SURRY POWER STATION, UNIT NO. 2

AMENDMENT TO FACILITY OPERATING LICENSE

Amendment No. 58
License No. DPR-37

ATTACHMENT TO LICENSE AMENDMENT NO. 58

HOT CHANNEL FACTOR NORMALIZEDOPERATING ENVELOPE

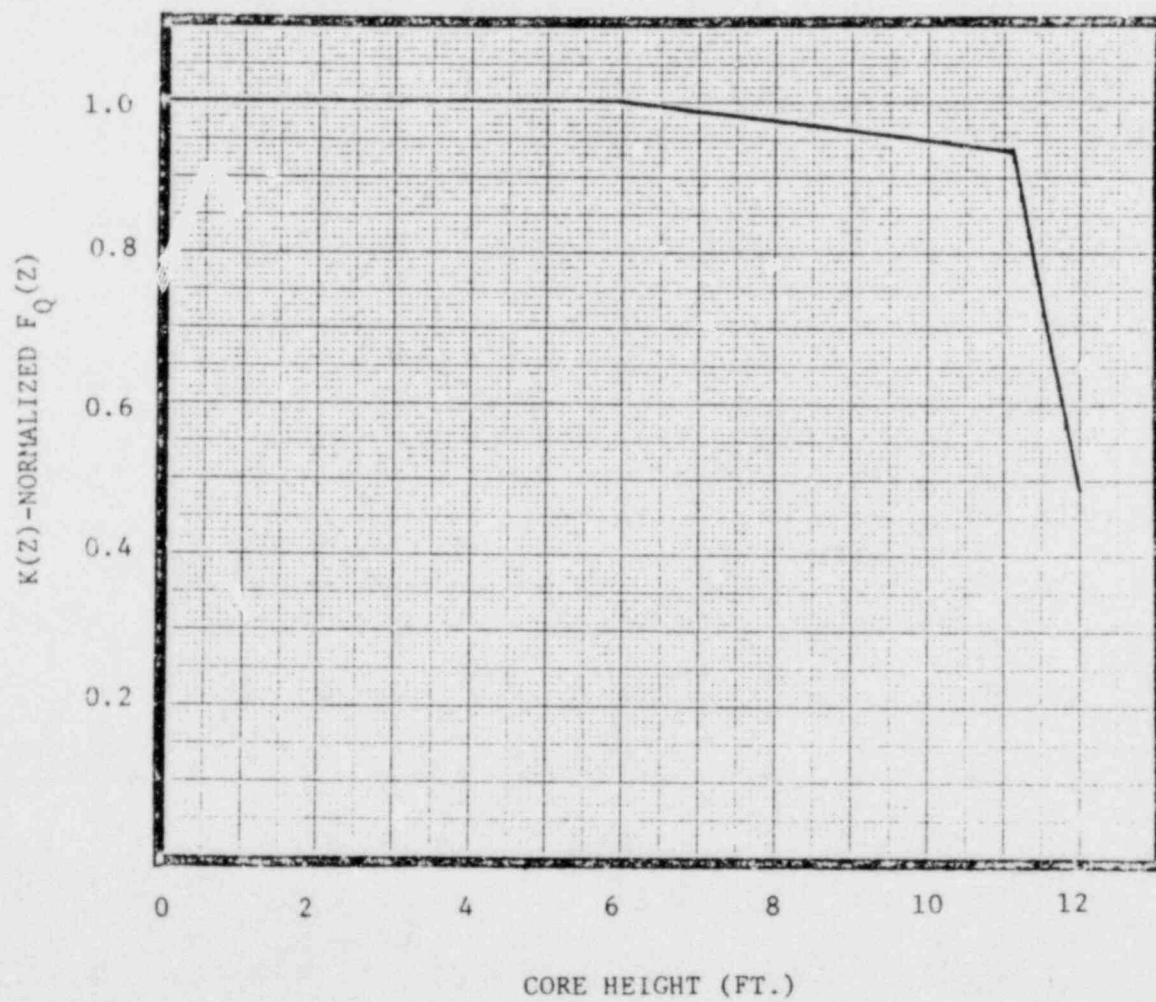
where P is the fraction of rated power at which the core is operating, $K(Z)$ is the function given in TS Figure 3.12-8a for Unit 1 and Figure 3.12-8b for Unit 2, Z is the core height location of F_Q , and $T(BU)$ is the interim thimble cell rod bow penalty on $F_{\Delta H}^N$ given in TS Figure 3.12-9.

It should be noted that the enthalpy rise factors are based on integrals and are used as such in the DNB and LOCA calculations. Local heat fluxes are obtained by using hot channel and adjacent channel explicit power shapes which take into account variations in radial (x-y) power shapes throughout the core. Thus, the radial power shape at the point of maximum heat flux is not necessarily directly related to the enthalpy rise factors. The results of the loss of coolant accident analyses are conservative with respect to the ECCS acceptance criteria as specified in 10 CFR 50.46 using an upper bound envelope of 2.05 (Unit 1) or 2.19 (Unit 2) times the hot channel factor normalized operating envelope given by TS Figures 3.12-8a and 3.12-8b.

$$F_Q(Z) \leq 2.05/P \times K(Z) \text{ for } P > 0.5$$

$$F_Q(Z) \leq 4.10 \times K(Z) \text{ for } P \leq 0.5$$

$$F_Q(Z) \leq 2.19/P \times K(Z) \text{ for } P > 0.5$$

$$F_Q(Z) \leq 4.38 \times K(Z) \text{ for } P \leq 0.5$$
